# Road & Bridge Design Publications

## Monthly Update – May 2026

Revisions for the month of **May** are listed and displayed below and will be included in projects submitted for the **September** letting.

LIGHT STANDARD DETAILS

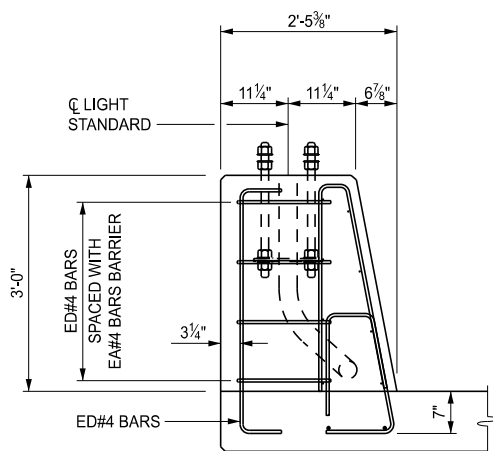
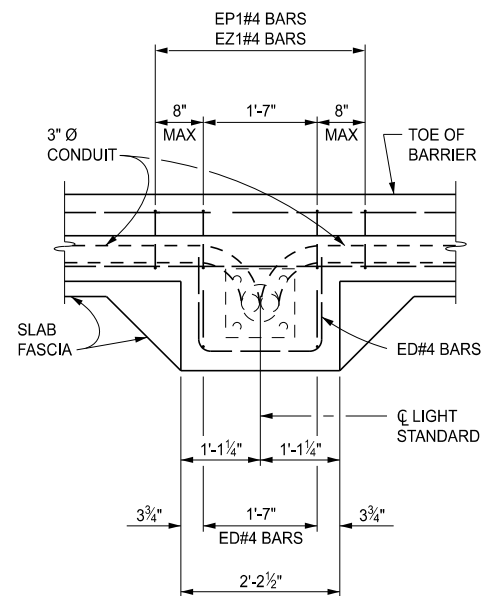
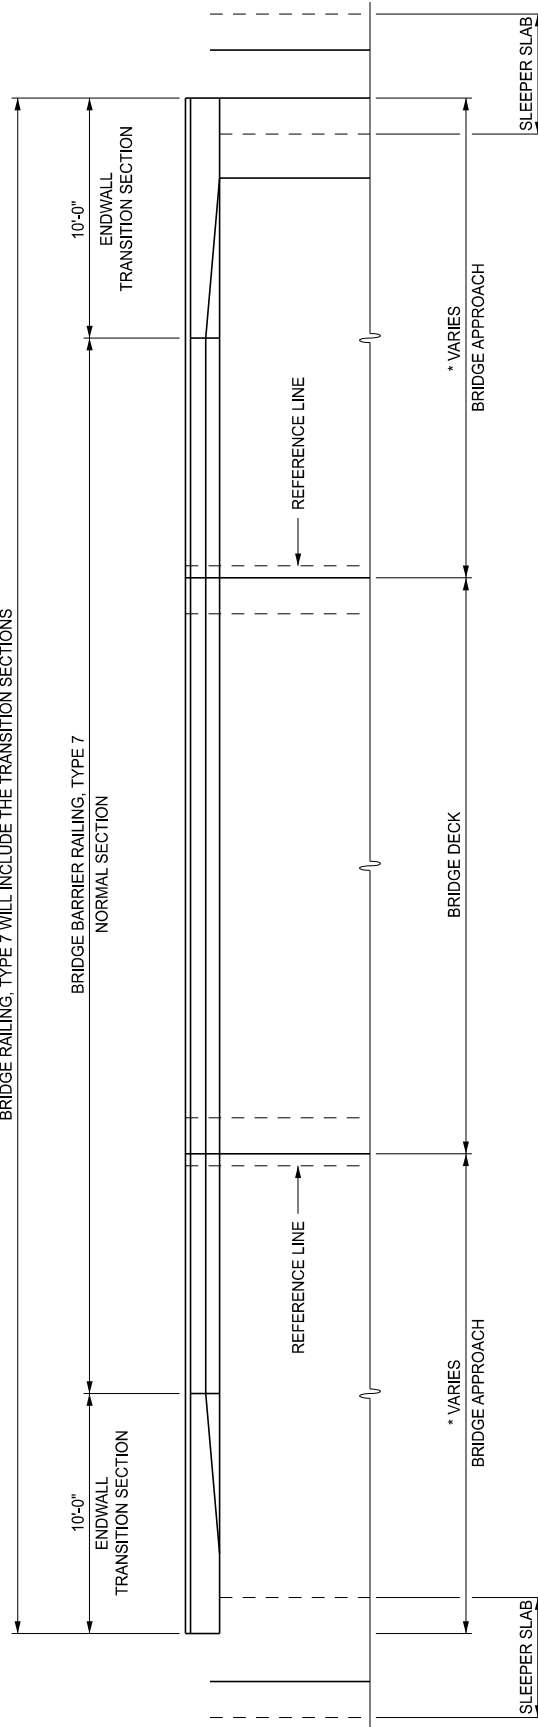
#### **B-28-A: Bridge Barrier Railing, Type 7:**

Revised dimension for bridge barrier light standard width.

NO AESTHETIC TREATMENT ON LIGHT STANDARD  $2'-2\frac{1}{2}" \times 1'-2\frac{7}{8}"$  PROTRUSION

LIGHT STANDARD DETAILS

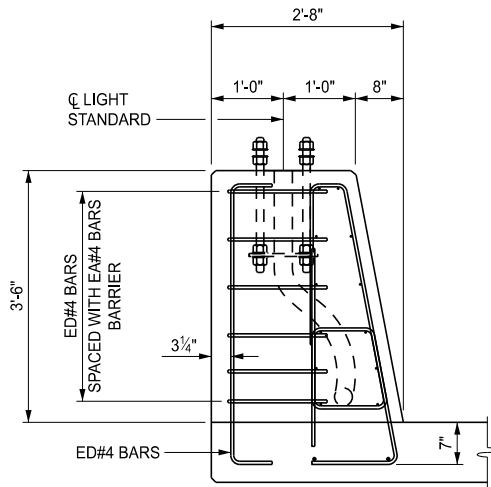
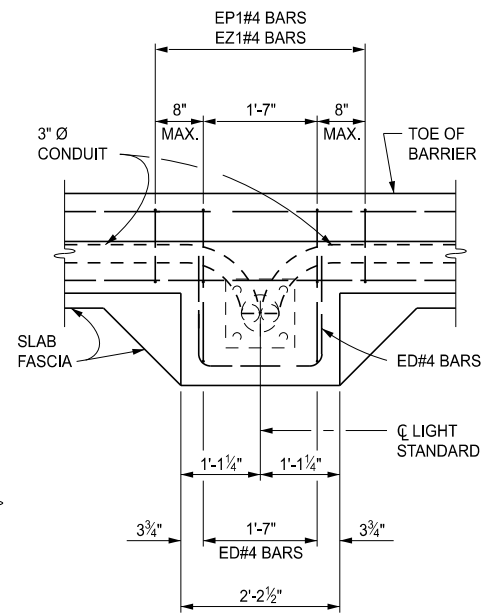
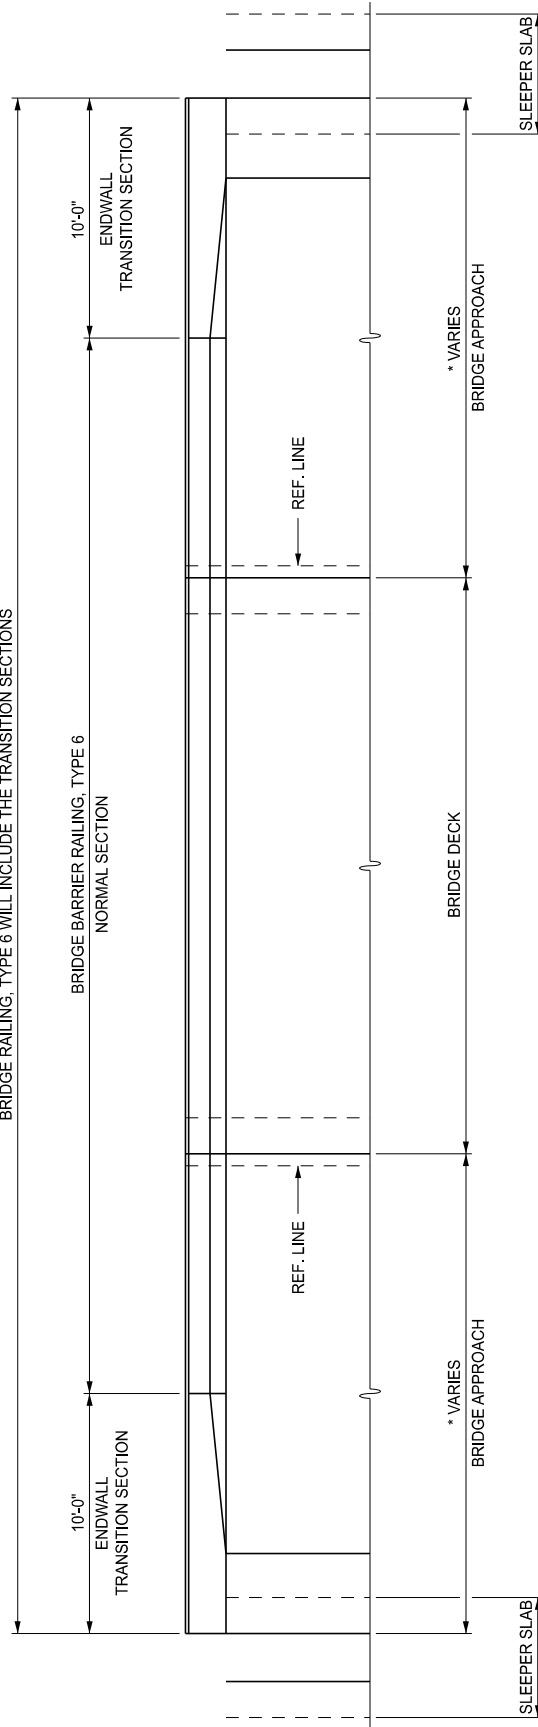
#### **B-29-A: Bridge Barrier Railing, Type 6:**

Revised dimension for bridge barrier light standard width.

NO AESTHETIC TREATMENT ON LIGHT STANDARD 2'-2 1/2" x 1'-2 1/4" PROTRUSION
